Re: 1409 Circle Drive  
Variance Request

Re: 1409 Circle Drive

**VARIANCE SITE PLAN**  
**GRADING, EROSION AND SEDIMENT CONTROL PLAN**

### CONFIRMATION OF PRE-FILE

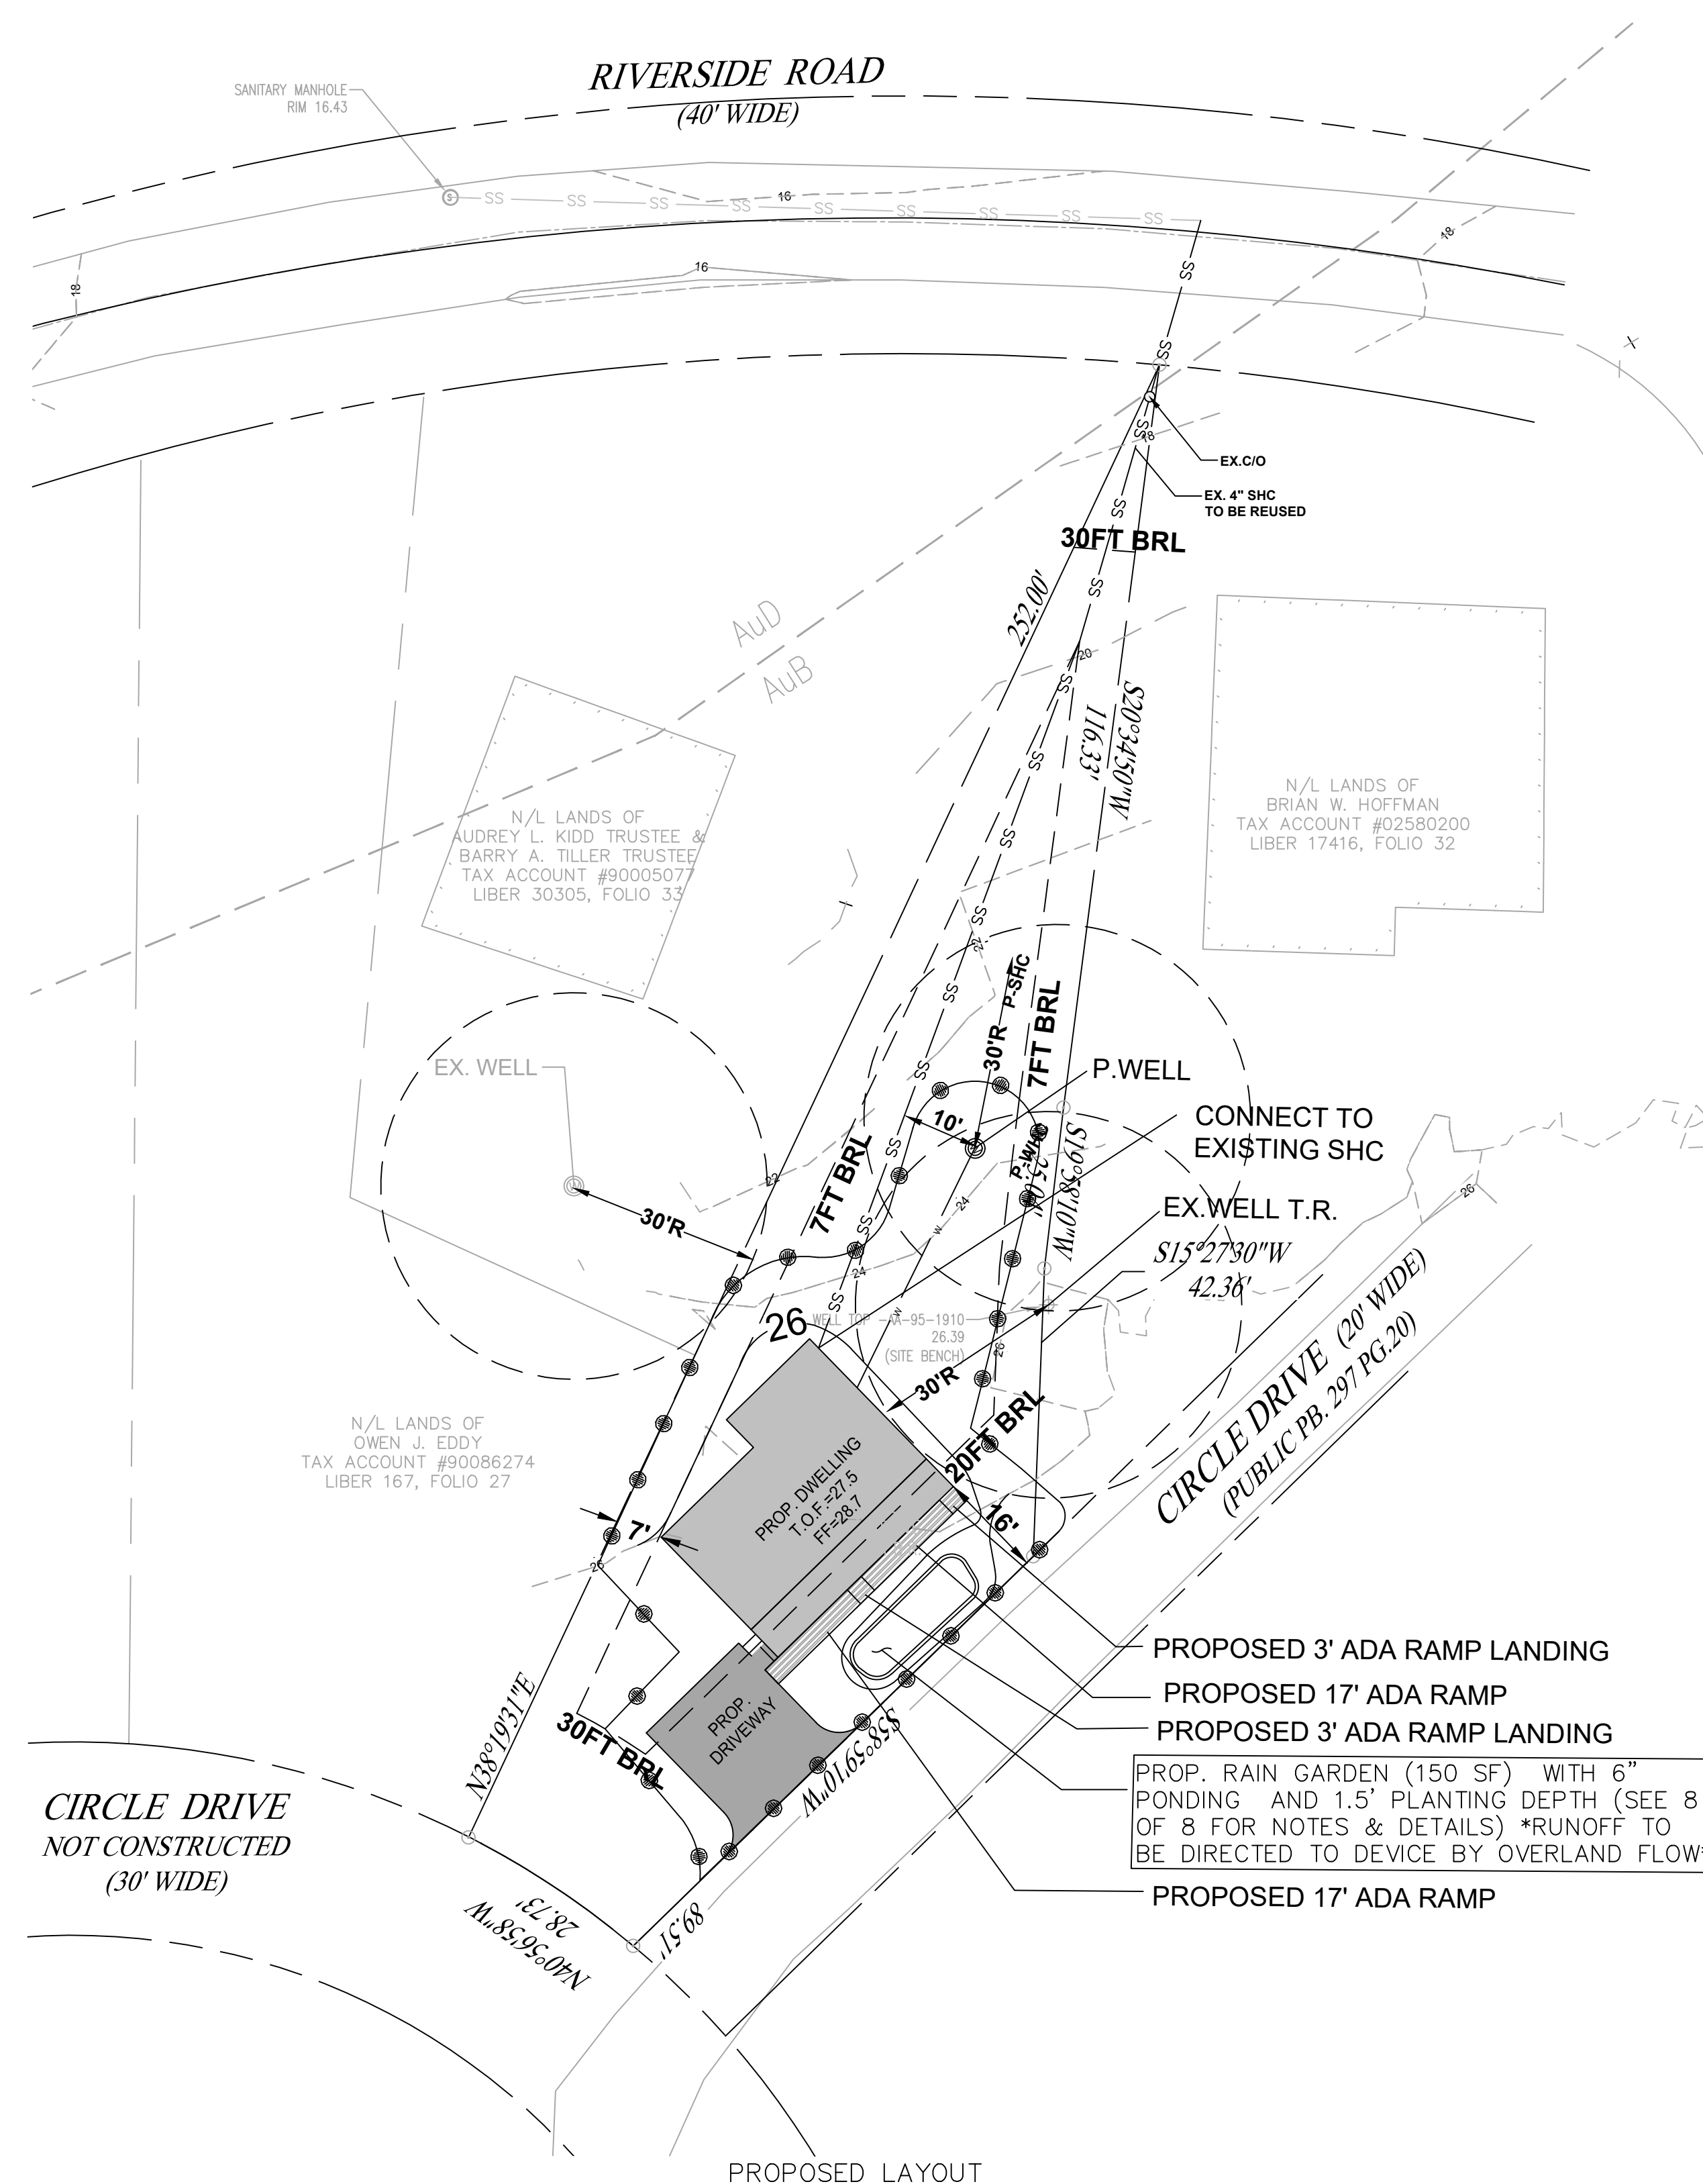
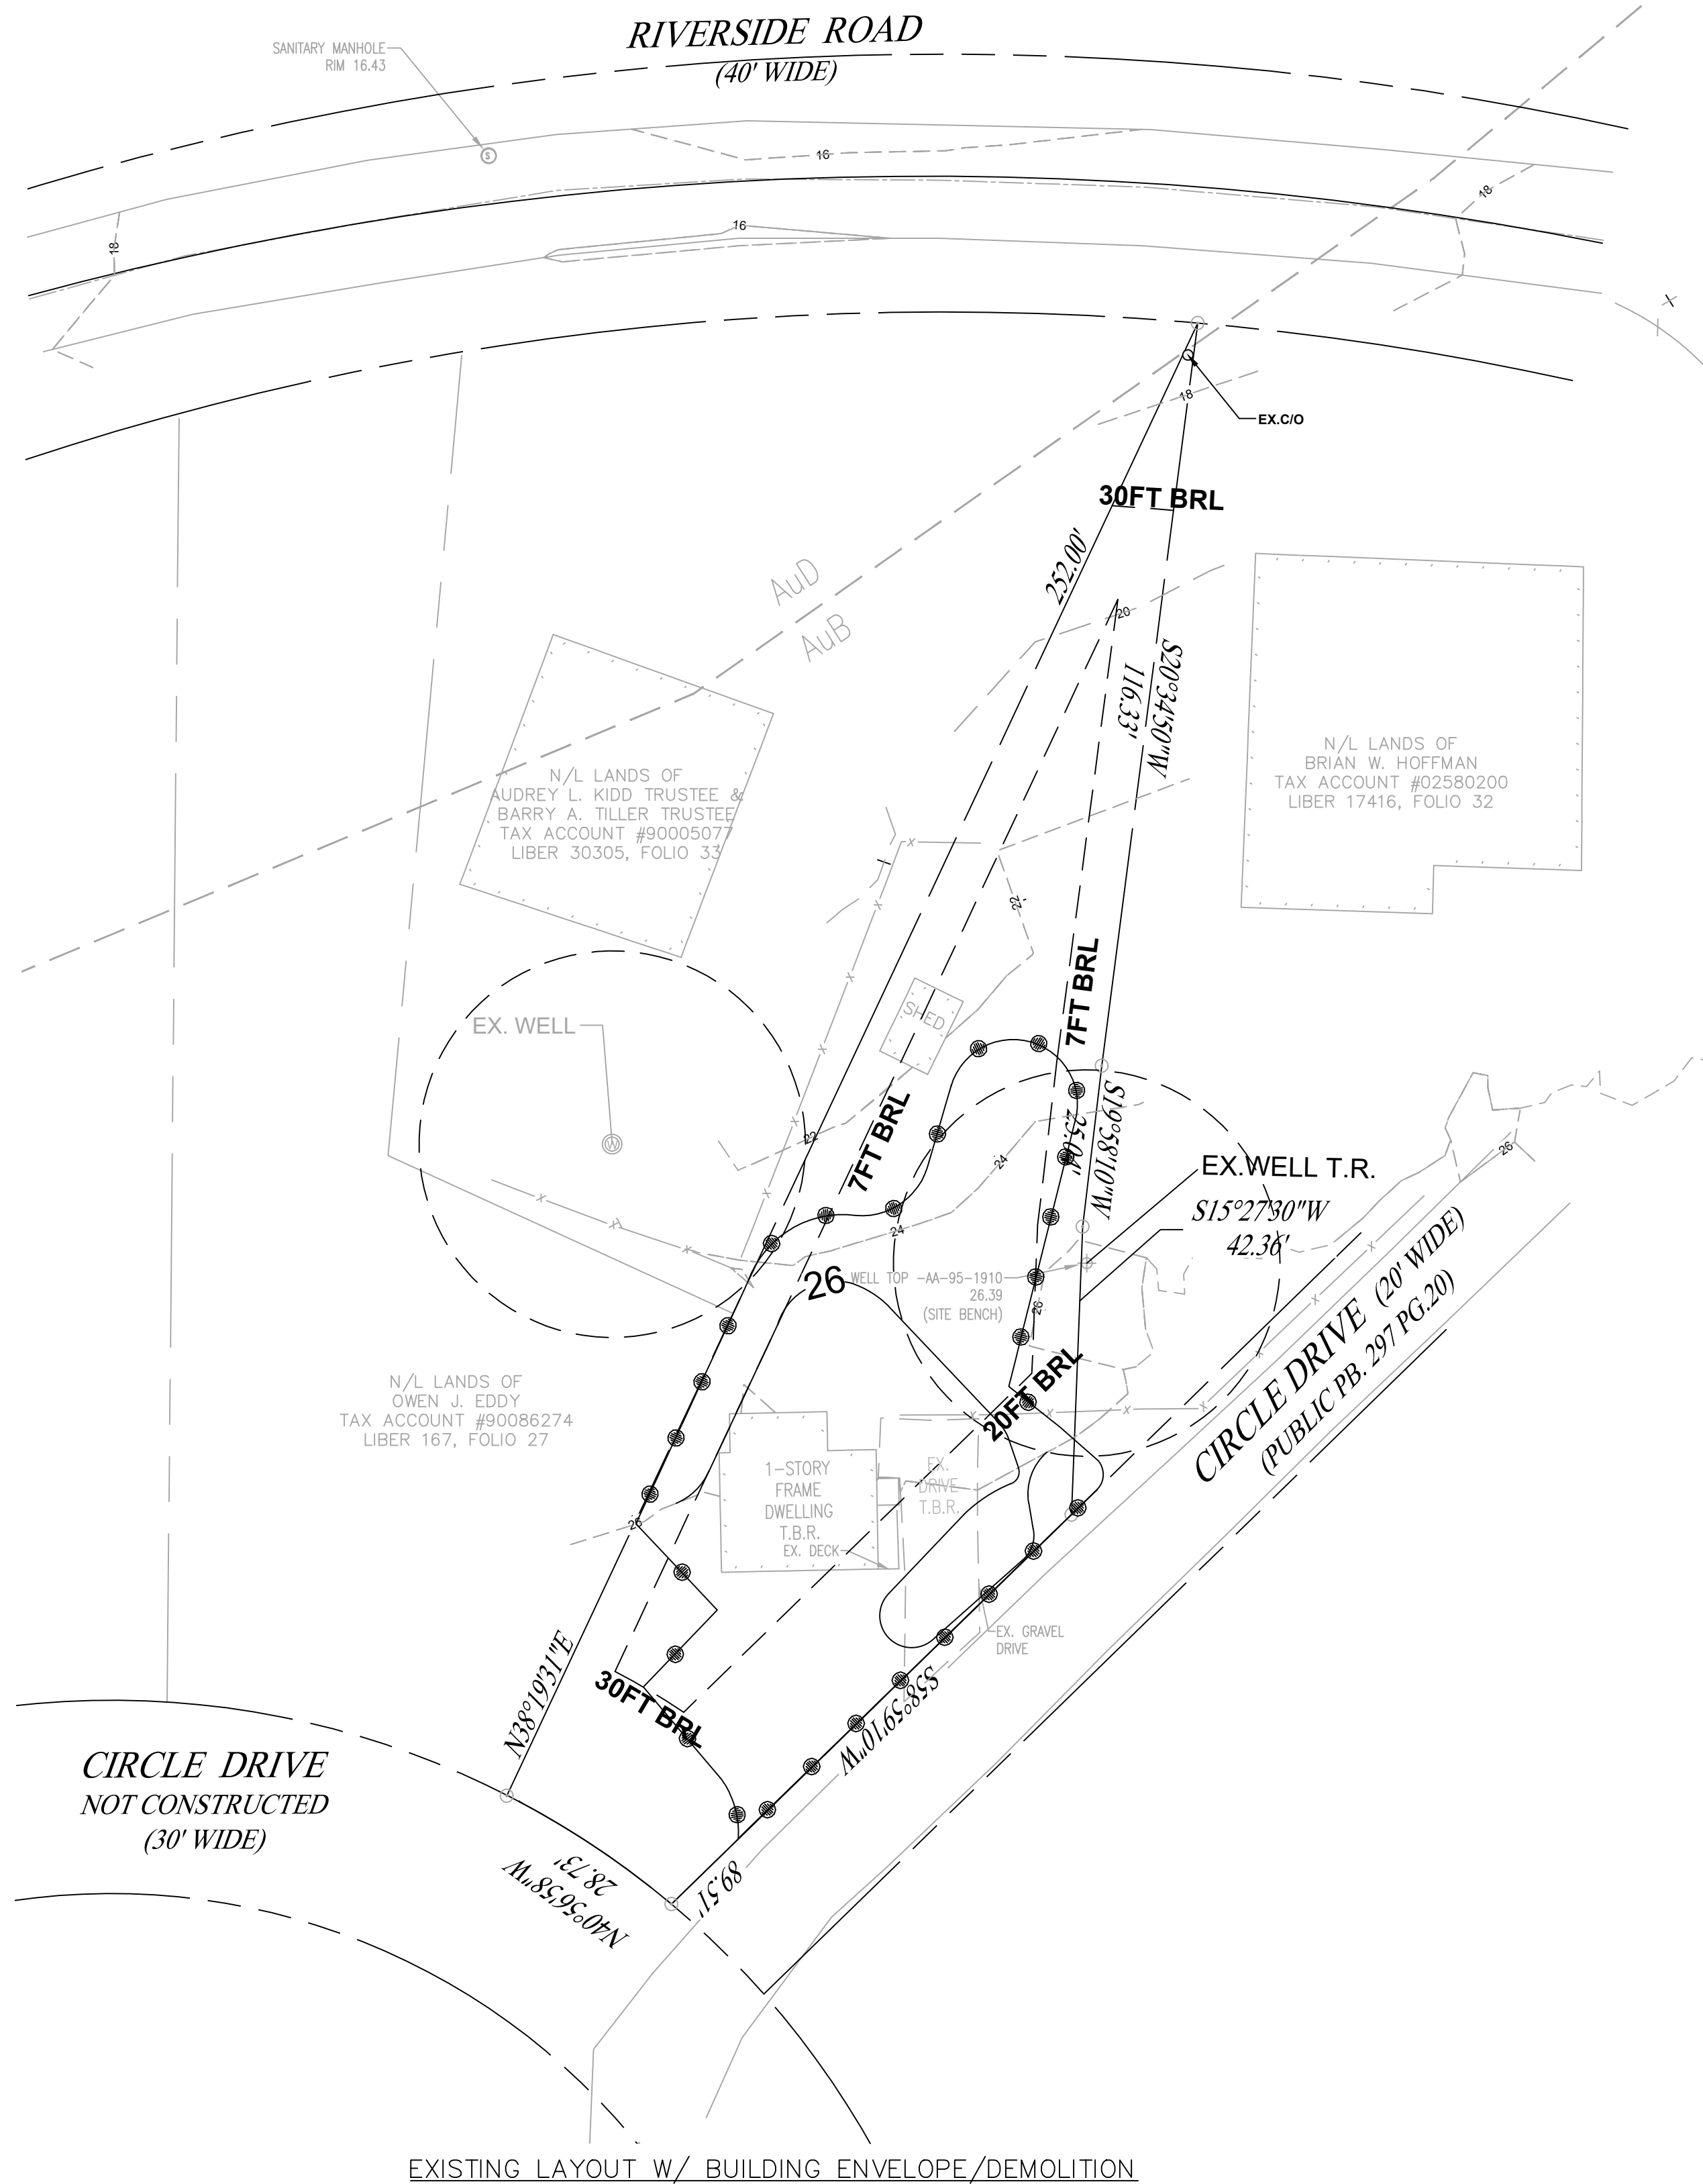
1. Stormwater management will be addressed through a rain garden.
2. The provided site plan did not show and label existing, removed, and proposed
3. All stormwater conveyance systems shall be designed so that no building or habitable structure, either proposed or existing, is flooded or has water impounded against it during the 100-year storm event.

4. Microscale stormwater facility(ies) design should incorporate safe conveyance for overflow discharges from 2, 10, 100-yr 24-hr storm events; plans should show overland relief paths for these storm events and ensure that no structures, or properties are negatively impacted or have water impounded against during these storm events.

5. Design professionals should review site runoff and potential (negative, adverse) impacts to neighboring properties, due to changed grades/elevation on a proposed project.

6. Ensure the proposed improvement including runoff, seepage, and slope saturation does not adversely impact the integrity of the slope and potential impact of slope failure.

7. A soil boring is required per practice. The suitability, and siting of proposed SWM practices should be reviewed. Soil boring information including verification of the suitability of in-situ soils for infiltration shall be submitted. Describe the site's hydrologic, and topographic characteristics and provide a recommendation on the feasibility of various BMPs.

1. The provided site plan now shows and labels existing, removed, and proposed.
2. All stormwater conveyance systems will be designed such that no proposed or existing structures are flooded or have water impounded against them during the 100-year storm event.

3. Grading plans will show overland relief paths for storm events such that no structures or properties are negatively impacted or have water impounded during 2, 10, and 100-year storm events.

4. Design professionals will review the site runoff to determine whether there are potential adverse impacts to neighboring properties due to changed grades/elevations during the grading permit phase of this project.

5. The proposed improvement does not adversely affect the integrity of any slope as there are none located on the site.
6. A soil boring will be provided, along with a description of the site's hydrologic and topographic characteristics and a recommendation on the feasibility of various BMPs during the final project design.
